SCHEMATIC,
UHF AMPLIFIER BD.
(1227-1303)

DWN	RFB	1/5/93	DWG. NO.	REV
CHK	DWB	1/25/94	1227-3303	4
REL	DWB	1/25/94	A	SCALE --- SHEET 1 OF 1

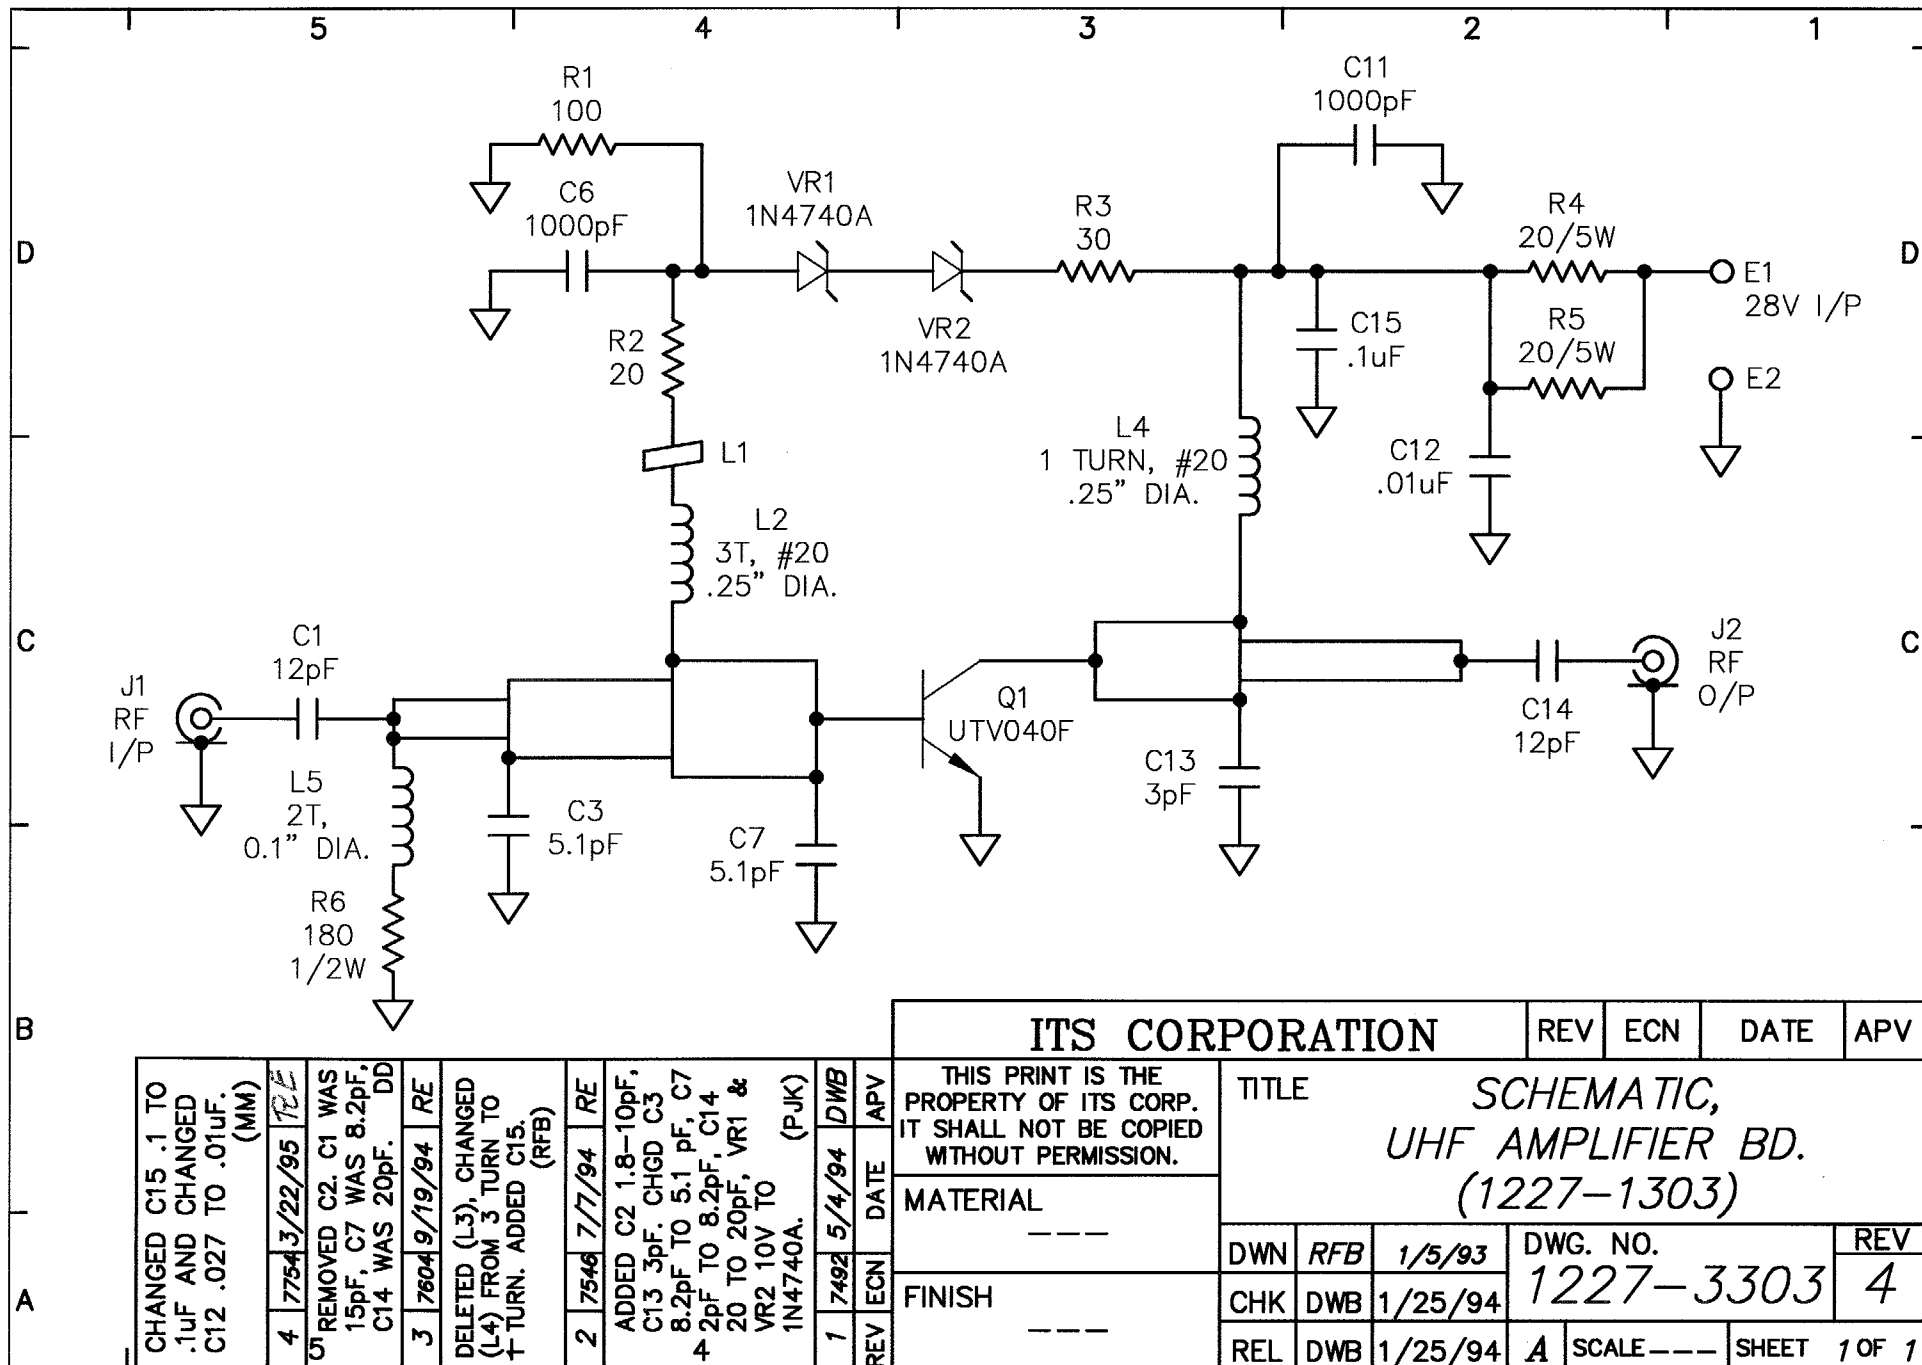
CHANGED C15 .1 TO .1uF AND CHANGED C12 .027 TO .01uF. (MM)	4 7754 3/22/95	RE
REMOVED C2. C1 WAS 15pF, C7 WAS 8.2pF, C14 WAS 20pF. DD	3 7604 9/19/94	RE
DELETED (L3), CHANGED (L4) FROM 3 TURN TO 1 TURN. ADDED C15. (RFB)	2 7546 7/7/94	RE
ADDED C2 1.8-10pF, C13 3pF. CHGD C3 8.2pF TO 5.1 pF, C7 4-2pF TO 8.2pF, C14 20 TO 20pF, VR1 & VR2 10V TO 1N4740A. (PJK)	1 7492 5/4/94	DWB
REV ECN	DATE	APV
